**PLANNED UNIT DEVELOPMENT &
SIDEWALK WAIVER STAFF REPORT****Date: June 15, 2006****DEVELOPMENT NAME**Joel Ridley
(Burt Williams Construction, Agent)**LOCATION**3700 Demetropolis Road
(West side of Demetropolis Road, 2/10 mile± south
of Government Boulevard)**CITY COUNCIL
DISTRICT**

The applicant is requesting approval for a Planned Unit Development, to allow multiple buildings on a single building site, and a waiver of the sidewalk requirements along Demetropolis Road.

SITE PLAN

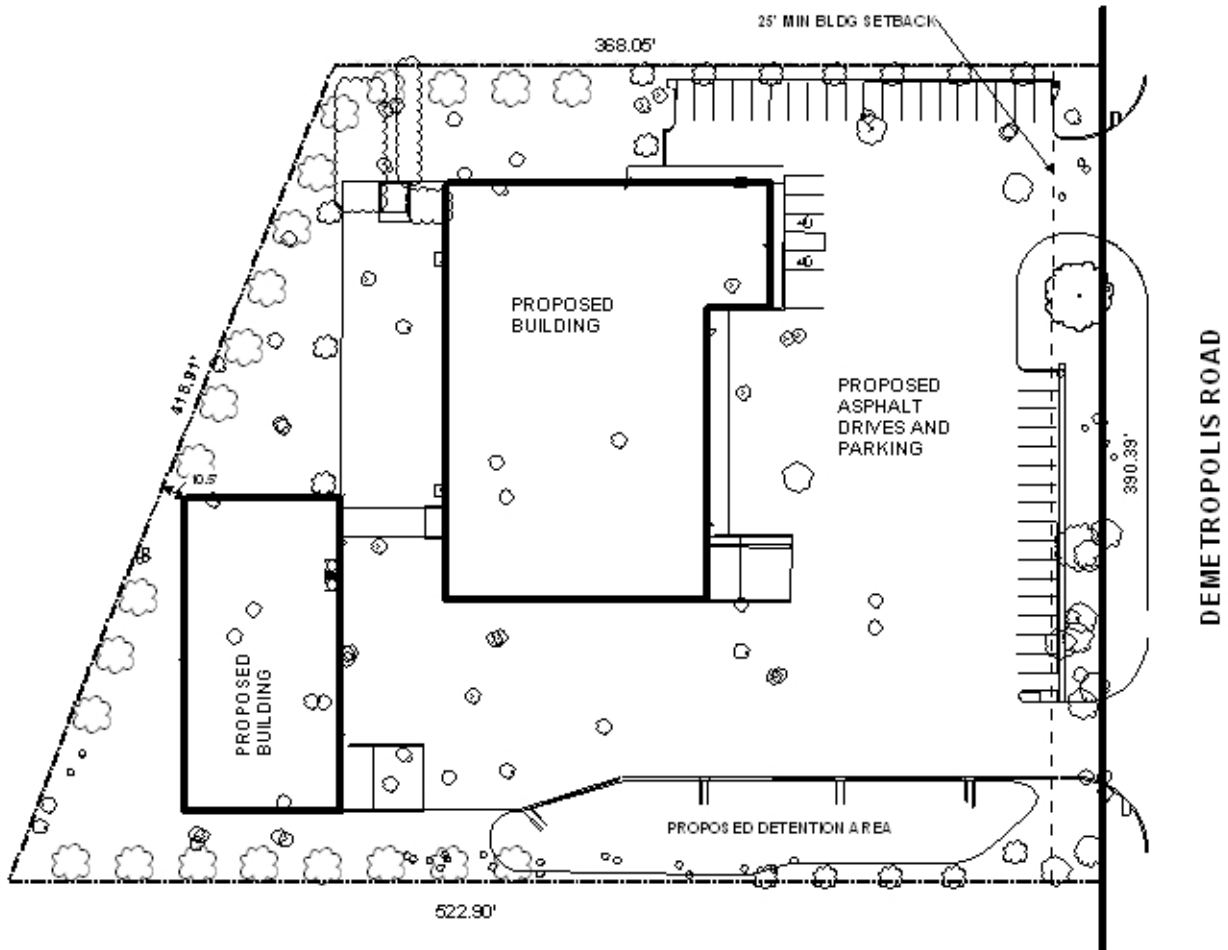
As proposed the site plan illustrates two buildings, the building (10,952 square-feet) to the rear of the site will be used as warehouse space, and the main warehouse building (26,417 square-feet) will have 6 full time warehouse employees and approximately 4,800 square-feet for retail/office use. The site plan illustrates parking spaces in excess of the minimum requirements (18 parking spaces) for the buildings shown, and the circulation plan appears to meet the requirements of the Zoning Ordinance.

Regarding the Sidewalk Waiver request, the applicant states that a steeply sloping ditch between the property line and the paved road and a 54-inch Live Oak located on the front property line would prohibit construction of a sidewalk to city standards. This statement is supported by the cross-section provided, and City Engineering and Urban Forestry have recommended the waiver.

Planned Unit Development: Based on the preceding, this application is recommended for approval, subject to the following conditions: 1) full compliance with landscaping and tree requirements of the Zoning Ordinance to be coordinated with Urban Forestry; and 2) full compliance with all municipal codes and ordinances.

Sidewalk Waiver: Based on the preceding, this application is recommended for approval.
